Well Abandonment Completion Report

FILE NUMBER D(14-12) 26 BCA
WELL REGISTRATION NUMBER 55-580071

Notice of Intent to
Abandon a Well

**Re: Variances for Five Monitor Wells
Registration Numbers 55-580068 through 55-580072**

PROPOSED REMEDIATION WELL (VEAS-1 - VEAS-5)
 CONSTRUCTION DETAIL

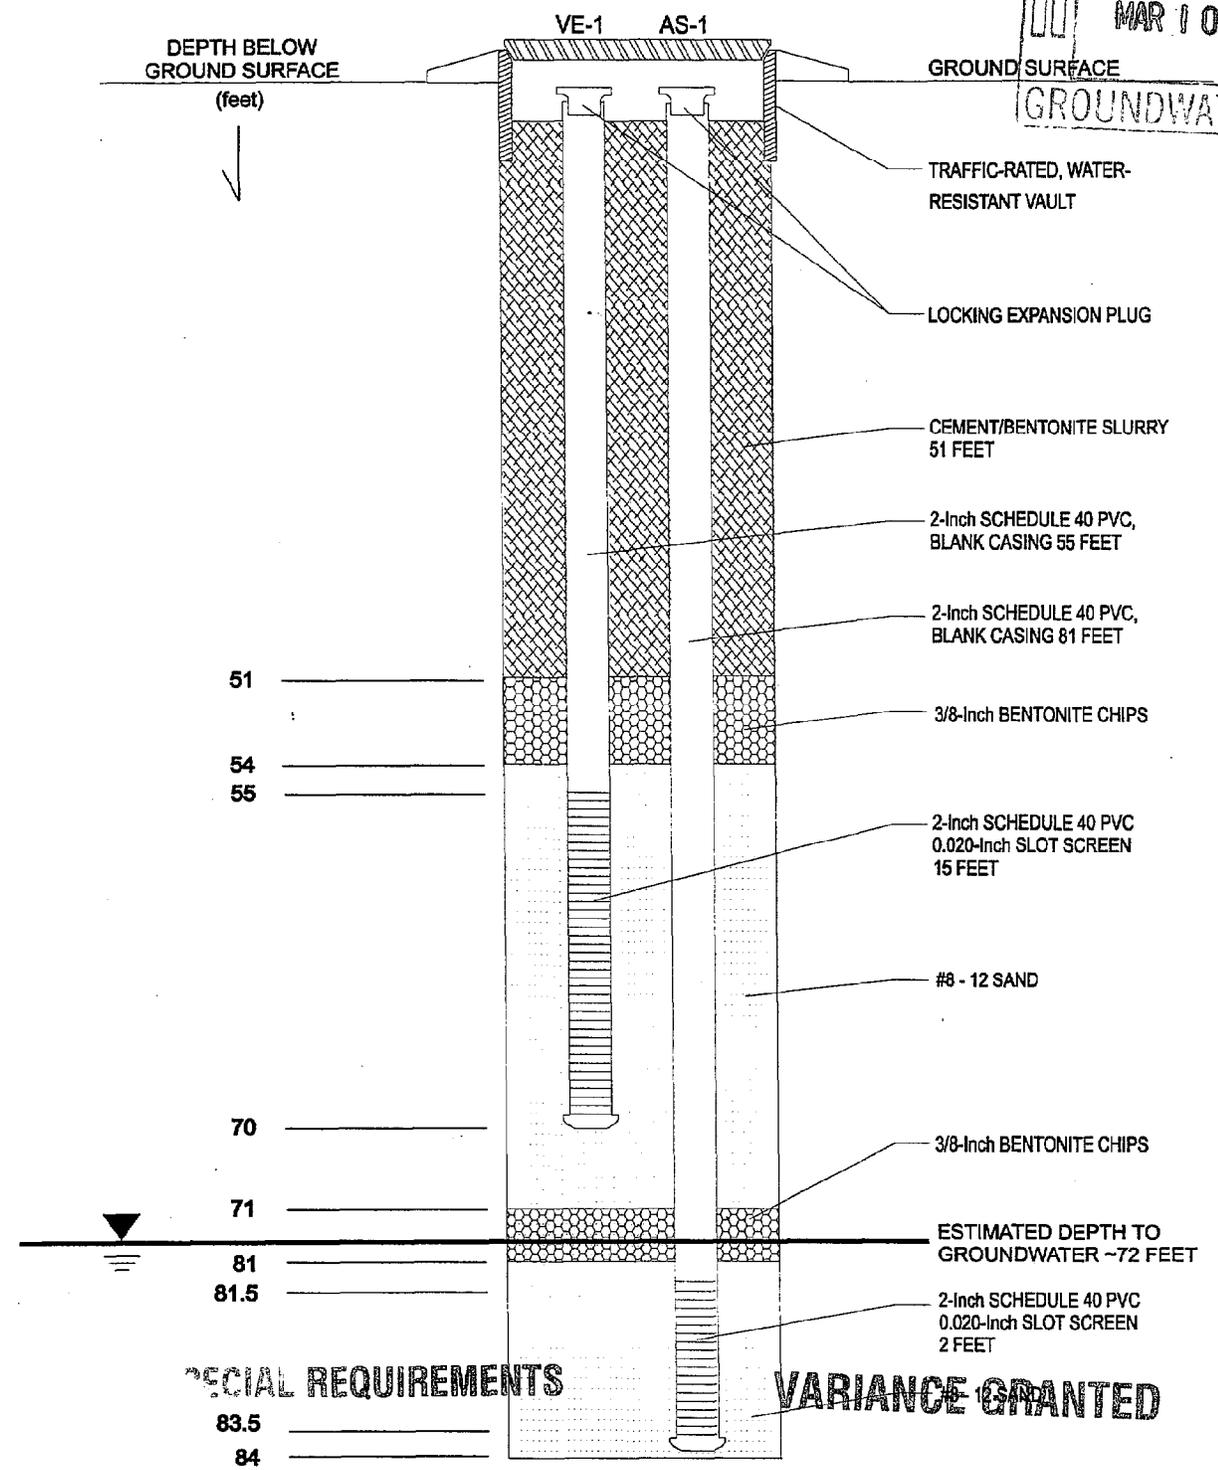
On Behalf of ATC Associates, Inc., Yellow Jacket Drilling, would like to request a variance for the construction of five (5) vapor extraction / air sparge wells located at Township 14S, Range 12E, Section 26, NE 1/4, SW 1/4, NW 1/4.

We request the following construction variances:

- * SCH 40 PVC casing will be used in lieu of the 20 foot steel surface casing.
- * The wells will be installed in sealed, flush grade, traffic-rated vaults because above-grade protective casing would interfere with traffic flow.
- * Due to the nested format, well screen will extend from 55' to 70' and from 81.5' to 83.5' BGS.

The Arizona Department of Water Resources approves this request for the following variances:

- Perforations may be installed between 55 and 83.5 feet below ground surface which is 17 feet above the record water level of 72 feet (R12-15-811.H.1.).
- Thermoplastic casing with a watertight cap may be used in lieu of steel (R12-15-811.B.1.).

The following *special requirements* are conditions for these variances (R12-15-821.):

- The PVC inner casings (risers) shall comply with ASTM Standard Guide D5092, Section 6.5.
- The wells shall be constructed per the "Variance Granted" Notice of Intention to Drill.
- The wells shall be abandoned (decommissioned) per A.A.C. R12-15-816.
